# Aberdeen Harbour Expansion Project

**Document Title:** Marine Scotland Act Part 4 Marine Licensing,  
Licence Number: 05964/16/0 Reference No: 05964  
Proposed Variation to Dredging Licence

Subject Dredge Depth & Area Amendments

### Extension of Dredge Depth

Drawing Title  
Geological Cross Section 2-2  
East Quay

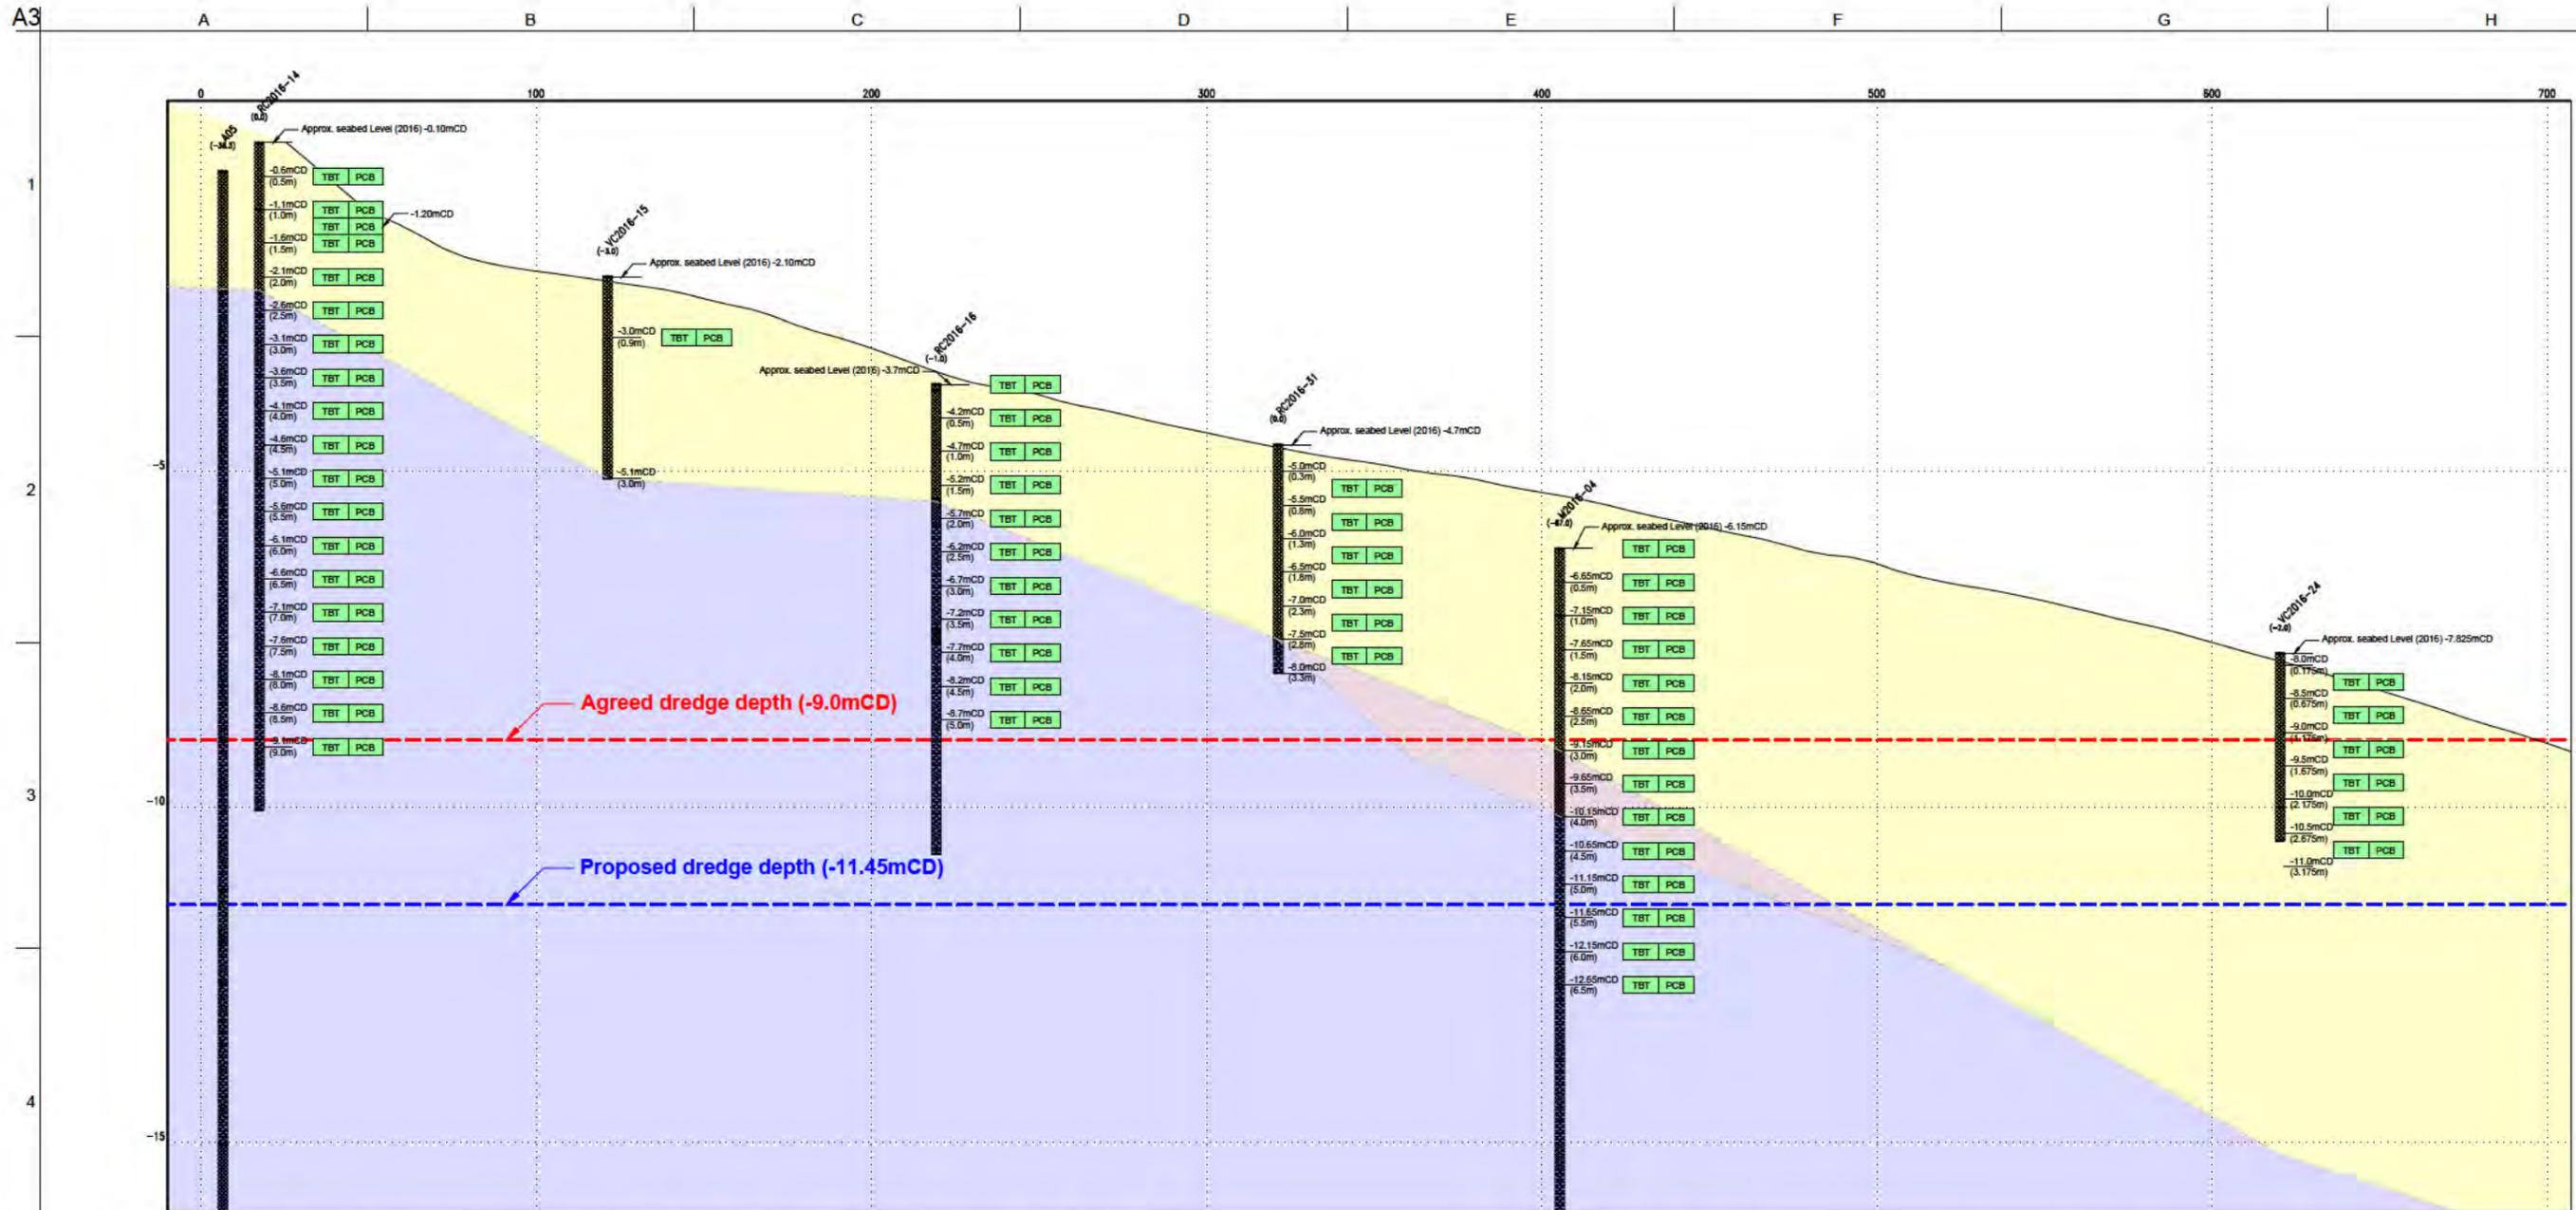
- *Dredging of East Quay. Increase seabed depth of approximately 10.5 metres below CD to 12.95m below Chart Datum (CD).*
- *Dredging of South East Pier. Increase seabed depth of approximately 9.0 metres below (CD) to 11.45m below CD.*

The locations of the ground investigations are shown on Figure 2. Figures 3 and 4 show geological cross sections and the proposed dredge depths at the East Quay and South East Pier.

Drawing Title  
 Results of sediment analysis  
 in vicinity of South East Pier  
 TBT & PCBs

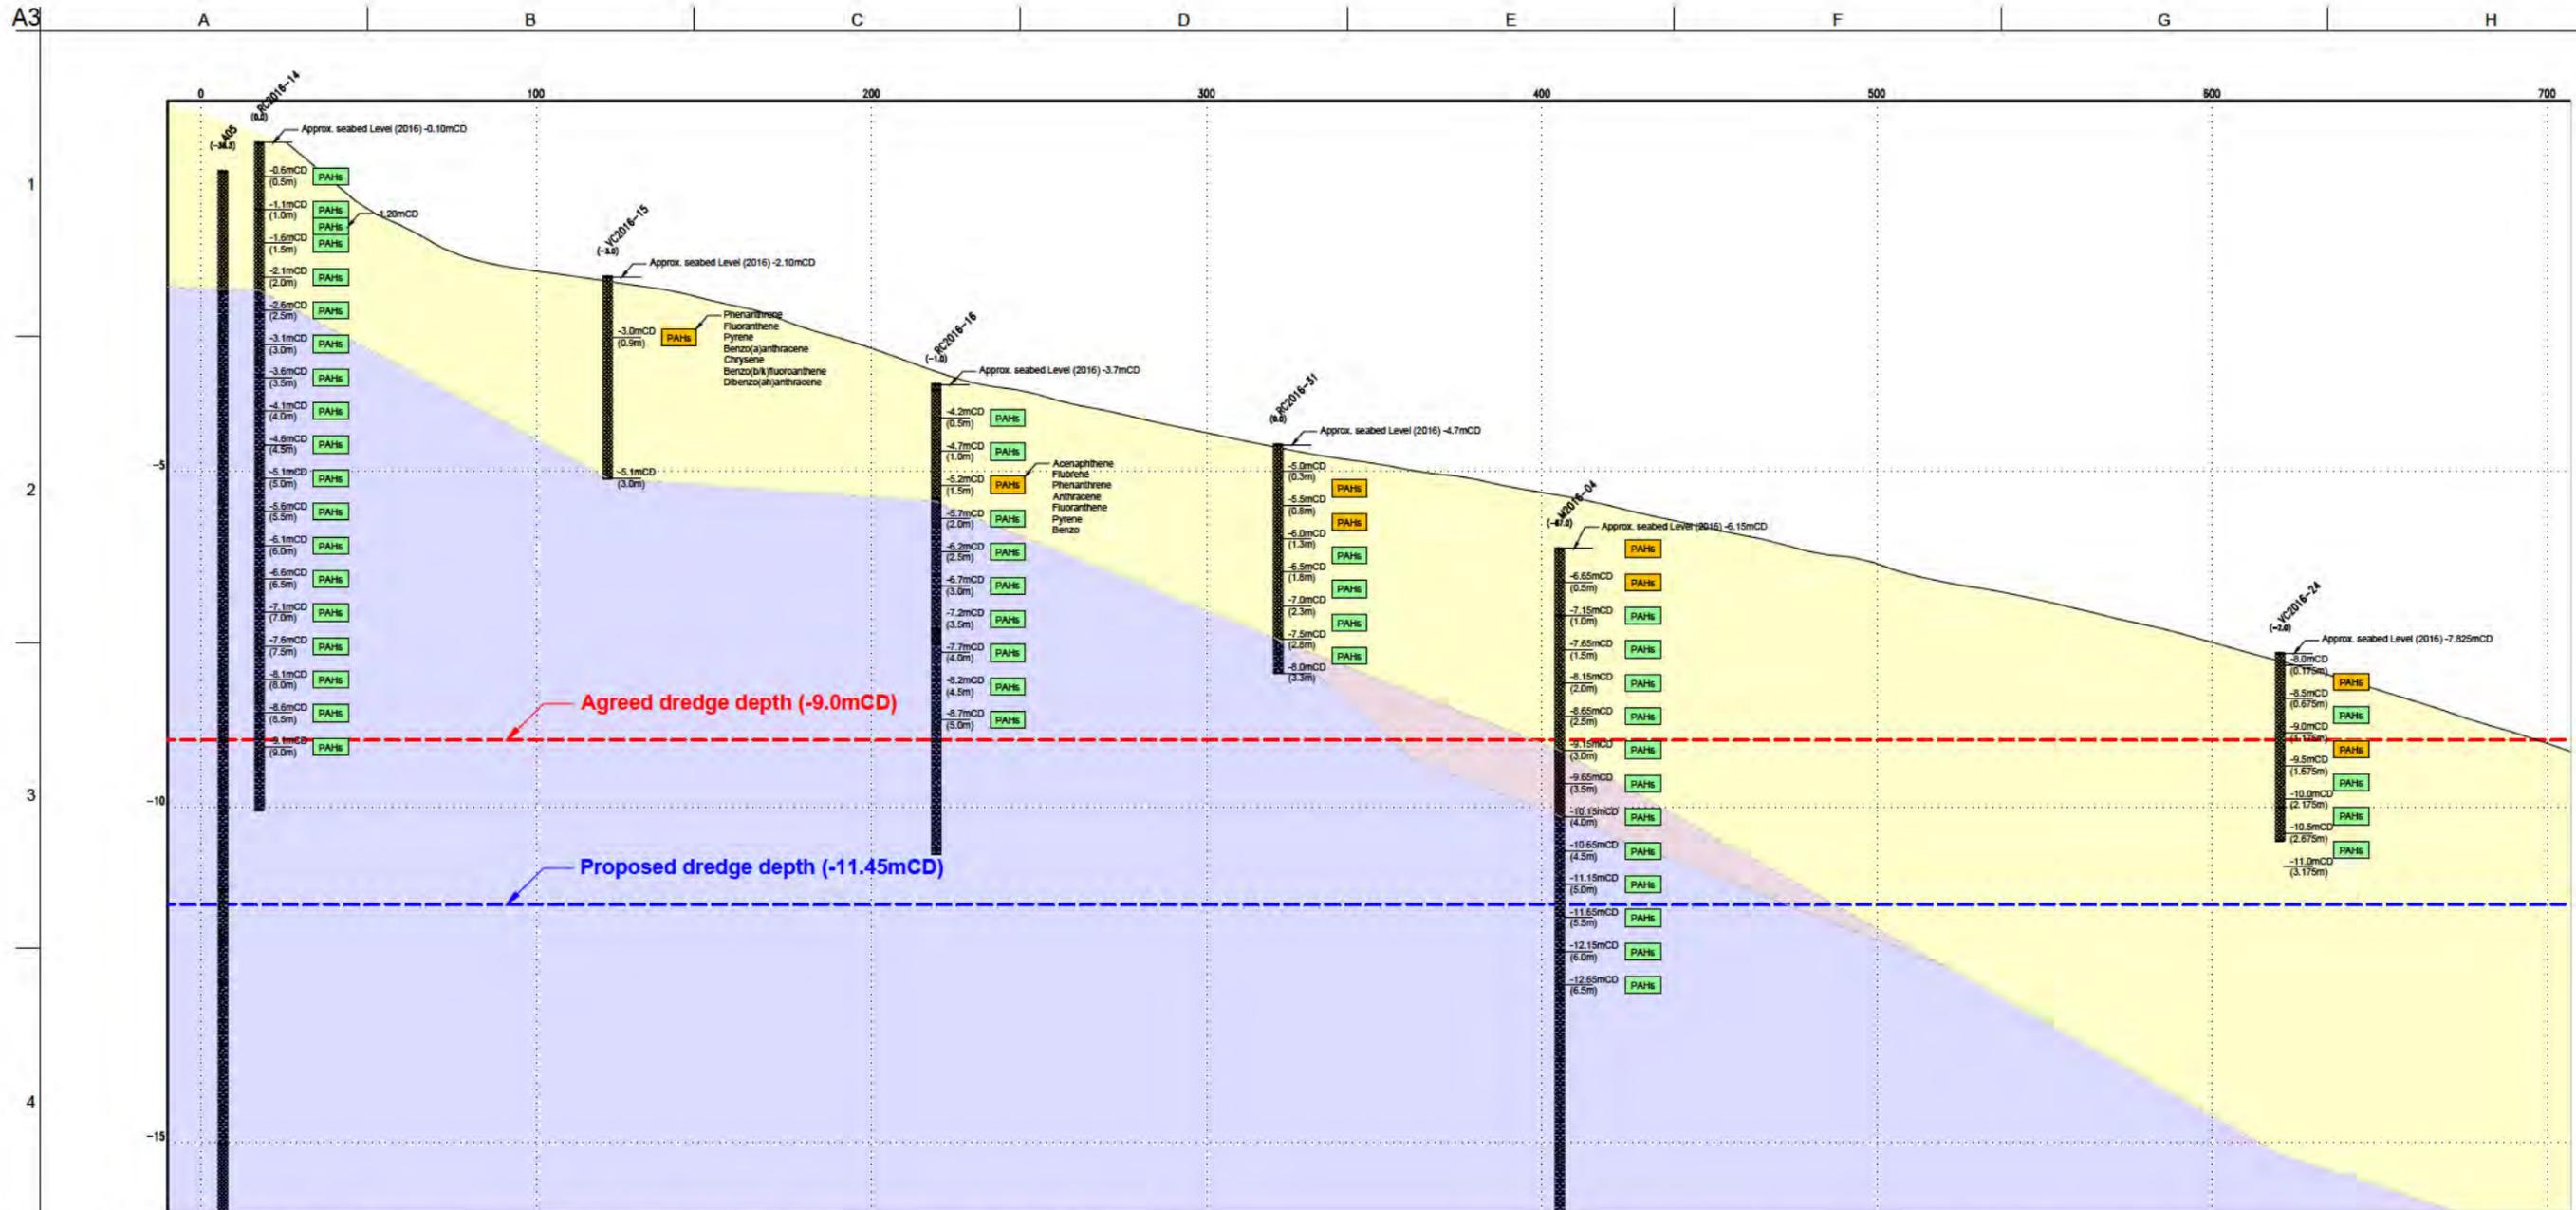
Figure 5 and 8 show that all of the PCB and TBT concentrations were recorded below action level 1.

Drawing Title  
Results of sediment analysis  
in vicinity of South East Pier  
PAHs

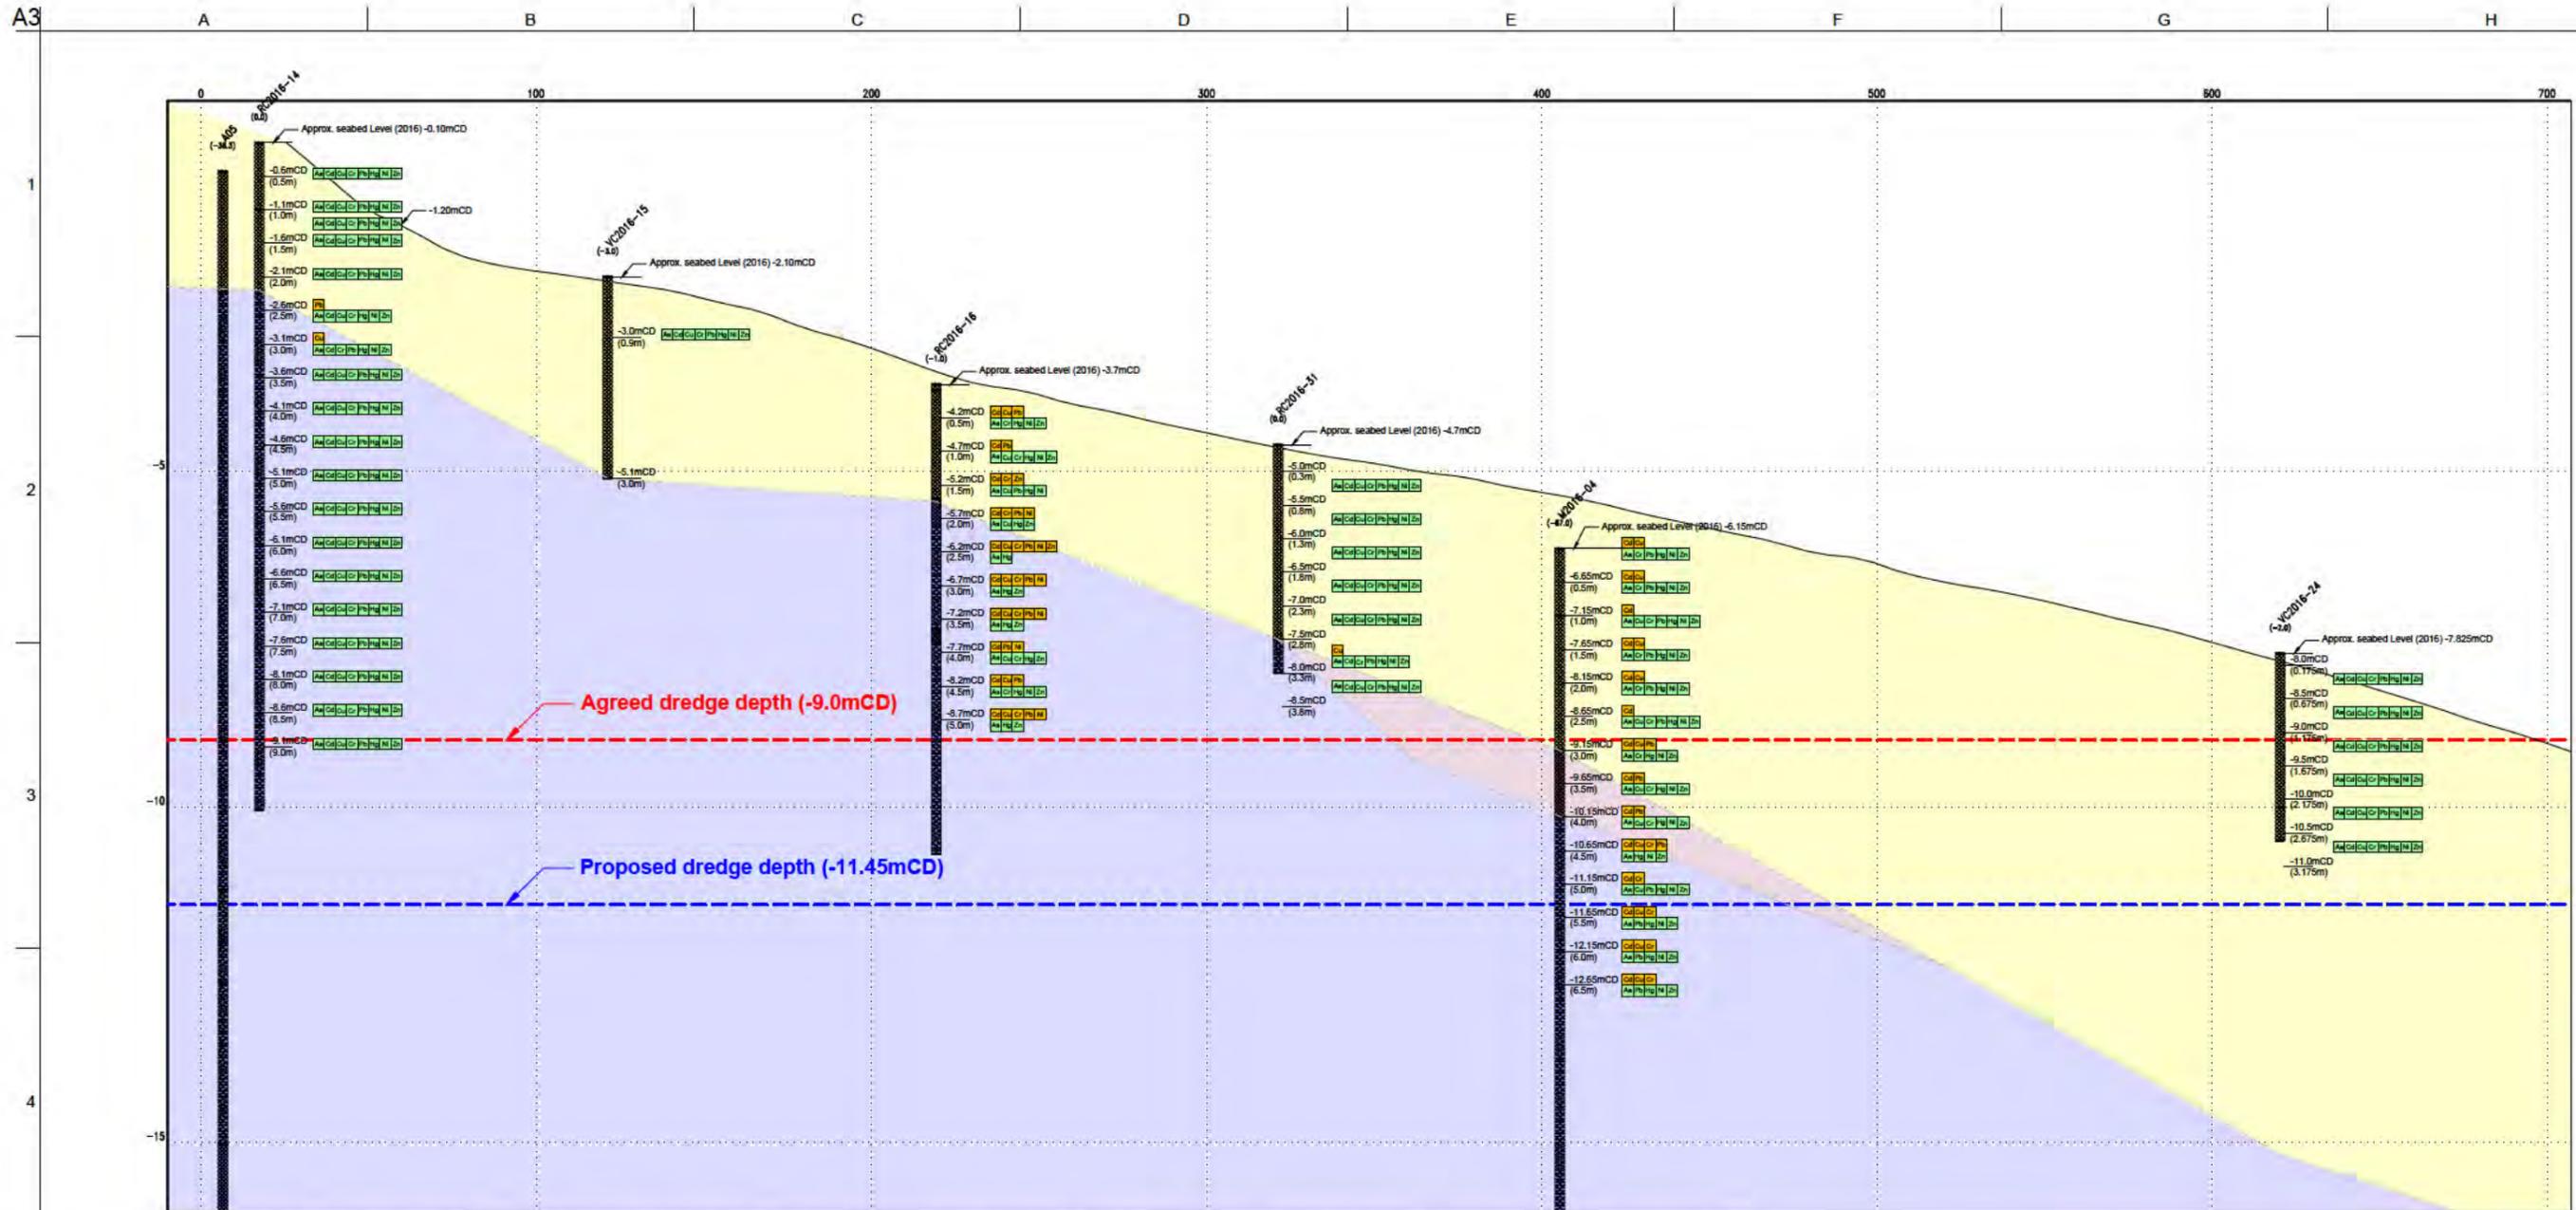
Figures 6 and 9 show that although some of the individual PAHs were recorded between action level 1 and action level 2, below -9m CD the results were all below action level 1.
